Subject: Transportation Consulting Services  
Proposed The Sanctuary at Ashland Mills (40B)  
10-60 Main Street, Ashland, MA

MDM Transportation Consultants, Inc. (MDM) is pleased to provide you with the following supplemental transportation review comments for the above-referenced project. These comments have been prepared based on review of Proponent's response memoranda prepared by Proponent dated April 1, 2025, project coordination meeting with the Town of Ashland department heads on Monday, April 14 2025 via Zoom, and a review of updated Site plans prepared by Bohler Engineering dated March 19, 2025 and documentation provided by Proponent as identified below. To facilitate response by Proponent, review items requiring response are noted in ***Bold Italic***.

## **AutoTurn Swept Path Modeling Examples**

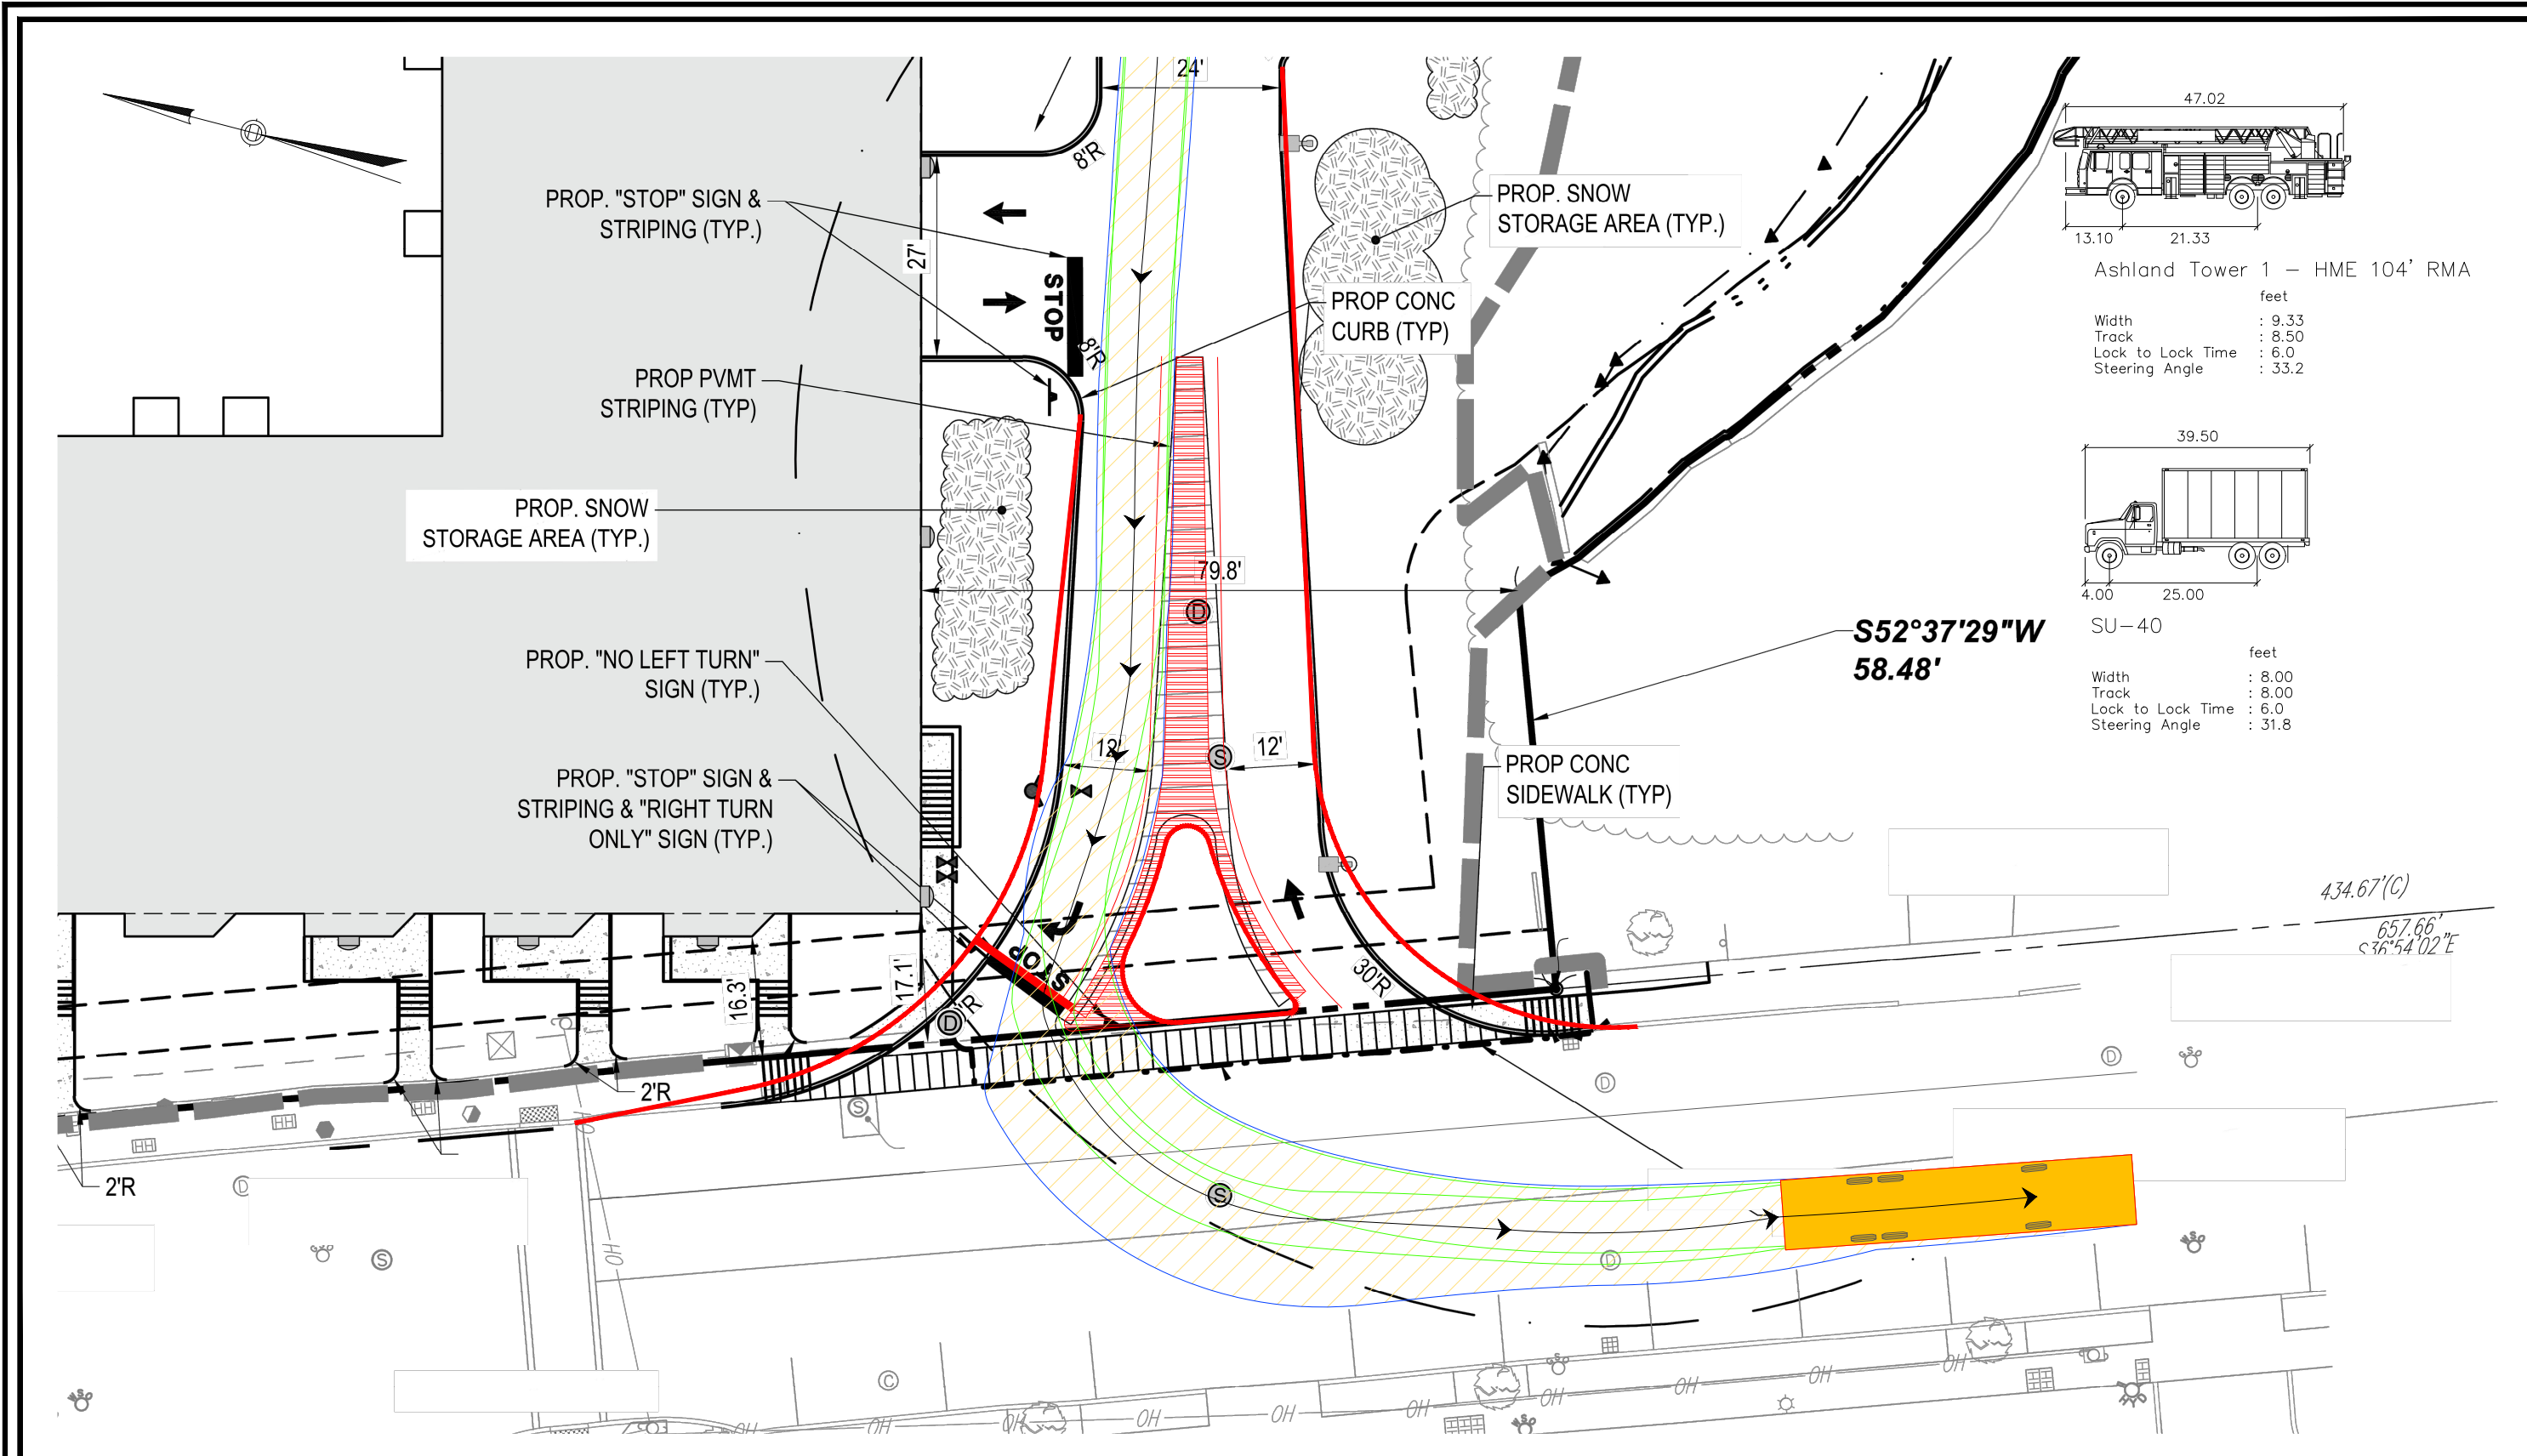
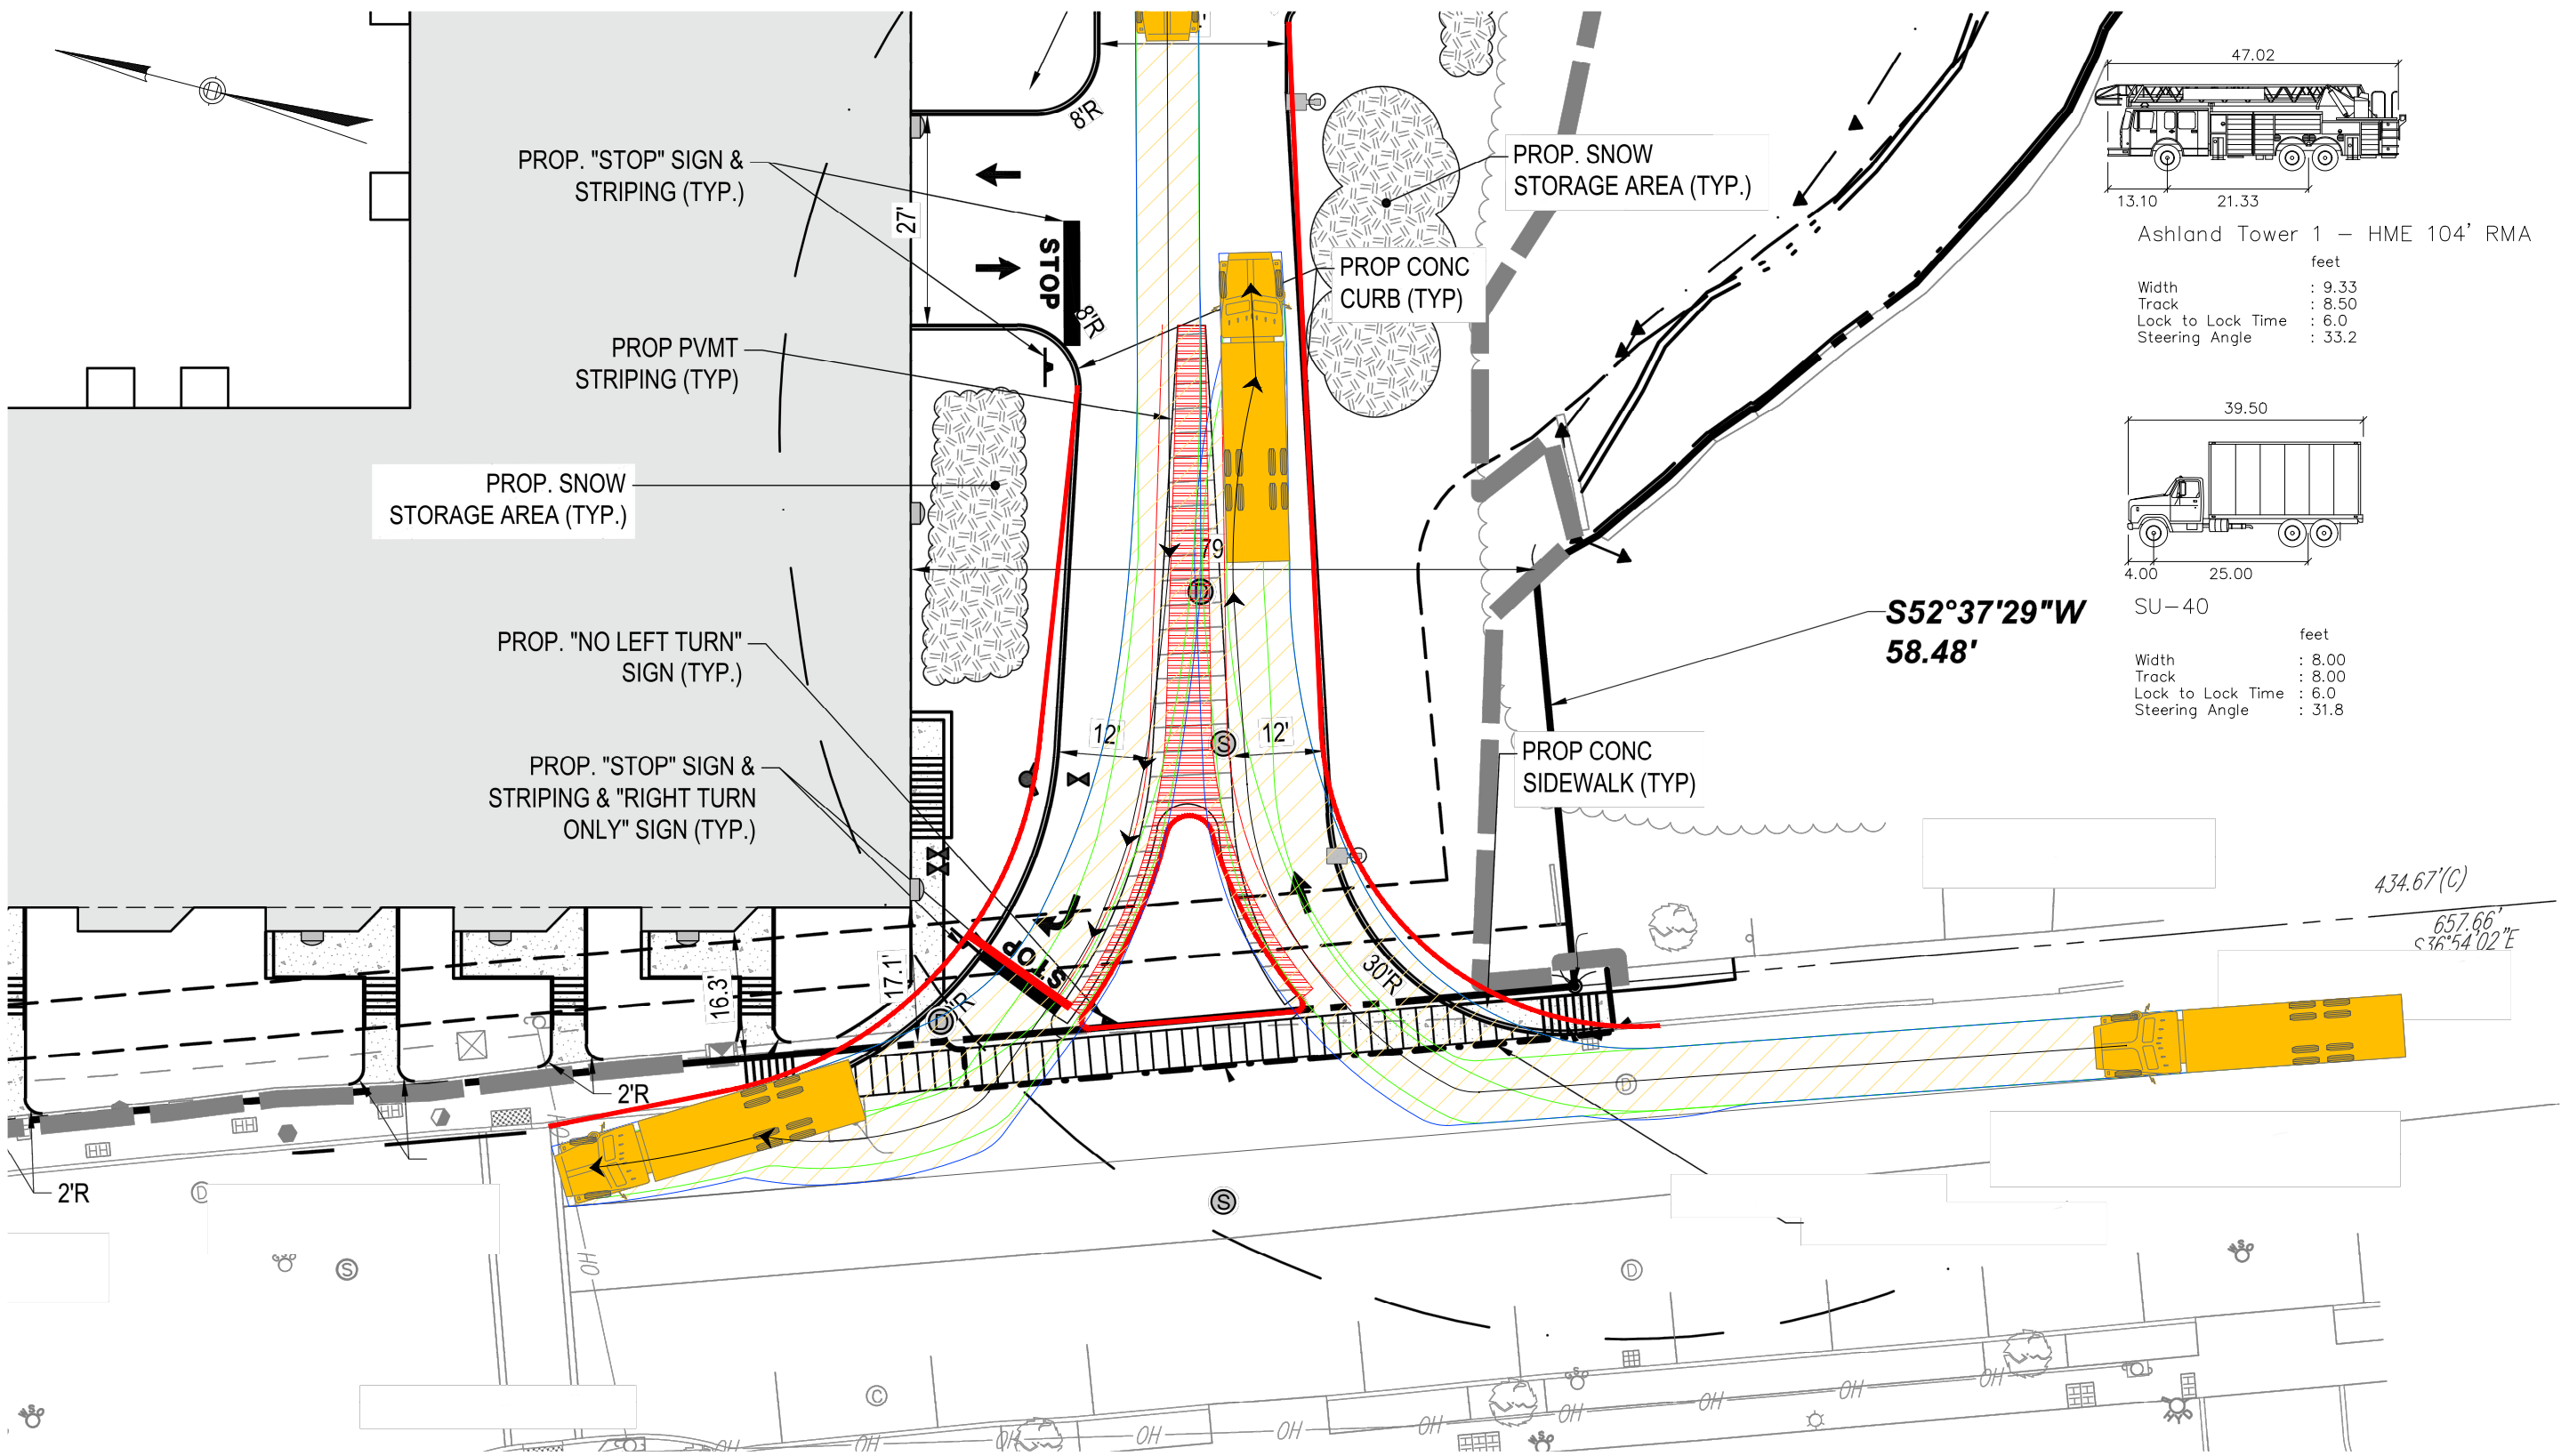
*Final Comment: A review of the AutoTurn exhibits (Single Unit 30, Single Unit 40, and Ladder Truck) indicate that the current design would not properly accommodate fire apparatus and service vehicle swept paths without encroaching into opposing travel lanes at Myrtle Street. Likewise, modification of the Main Street driveway geometry is necessary to properly accommodate vehicle sweeps. Additional input by Fire Department also requires accommodation for emergency vehicle (tower vehicle and ambulance) left-turn existing movement onto Main Street. Refer to attached redline plans prepared by MDM which*

*Final Comment: A review of the AutoTurn exhibits for service vehicles (Single Unit 30 and Single Unit 40) indicate that the current design would not properly accommodate service vehicle swept paths without encroaching into opposing travel lanes for movements into and out of the Driveways. MDM recommends modification to both driveways to accommodate the service vehicles for the Site. Refer to Comments 3(b) and 12(b) for detailed commentary. Refer to Comment 12(d) for recommendations relative to move-in/move-out vehicle staging.*

*Supplemental Comment (March 24, 2025): MDM does not concur that the driveway as proposed meets applicable design requirements for service, delivery, move-in or fire apparatus maneuvering whether these movements occur peak or non-peak. The skewed driveway alignment requires for each of these vehicle types a wide sweep into the opposing travel lane of Myrtle Street or (for entering movements) a wide sweep into the exiting lane of the driveway. This presents a significant safety concern that must be addressed by modifying the driveway alignment and/or adjusting curb radii so that movements do not impact opposing travel. See attached swept path exhibits which illustrate swept paths for various vehicle types based on currently proposed driveway design.*

*suggest (in concept form) the geometric changes necessary to address vehicle swept path movements and Fire Department maneuvering requirements. Design modifications include wider driveway lanes at Main Street with additional scored concrete panels and adjusted curb radii. The Myrtle Street driveway design modification include shifting the driveway alignment north with enlarged curb radius to accommodate right-turn movements by service and emergency apparatus. Shifting the Myrtle Street driveway alignment north would have the added advantage of increasing sight distance to Main Street by approximately 20-30 feet, thereby ensuring that more than the absolute minimum SSD criteria may be met for the driveway.*
